# Access Compliance Report

## Public Rights-of-Way

Intersection ID: 32203	Main Street: CAMBRIDGE_GREEN_DR	Cross Street: KEW_GARDENS_LN	Location: NW
ADA ID: AC7563AACA06	Ramp Type: Perp	Initial Pass/Fail: Fail	Overall Compliance: No
Severity Score: 13.75			
Codes/Mitigation Info/Possible Solution		Field Measurements/Component Compliance

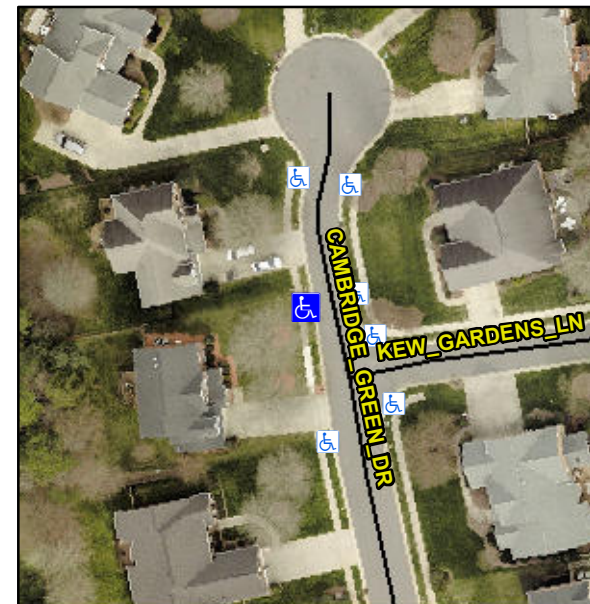
**Not Found, R304.2.2, R304.5.3**

Compliance	Description	Data	Compliance	Description	Data
N/A	Ramp Length (in)	48.0	No	Ramp Slope (%)	8.4
Yes	Ramp Width (in)	48.0	No	Ramp XSlope (%)	2.5
N/A	Flare Type LT	N/A	N/A	Flare Type RT	N/A
N/A	Flare Slope LT (%)	N/A	N/A	Flare Slope RT (%)	N/A
N/A	Flare Traversable LT?	N/A	N/A	Flare Traversable RT?	N/A
N/A	Landing Length (in)	N/A	N/A	DWS Provided?	N/A
N/A	Landing Width (in)	N/A	N/A	DWS Contrast?	N/A
N/A	Landing Slope (%)	N/A	N/A	DWS Length (in)	N/A
N/A	Landing X Slope (%)	N/A	N/A	DWS Full Width?	N/A
N/A	Landing Curb? (Y/N)	N/A	N/A	DWS Offset (in)	N/A
N/A	Shared Landing?	N/A			
N/A	Gutter Ponding?	N/A	N/A	Gutter Slope (%)	N/A
N/A	Gutter Lip Ht (in)	N/A	N/A	Gutter X Slope (%)	N/A
N/A	Painted X Walk1?	No	N/A	Painted X Walk2?	N/A
	X Walk 1 Direction	To E		X Walk 2 Direction	N/A
N/A	X Walk 1 Width (in)	N/A	N/A	X Walk 2 Width (in)	N/A
	X Walk 1 Slope (%)	5.5		X Walk 2 Slope (%)	N/A
	X Walk 1 X Slope (%)	1.4		X Walk 2 X Slope (%)	N/A

**Remove & Replace Entire Ramp.**
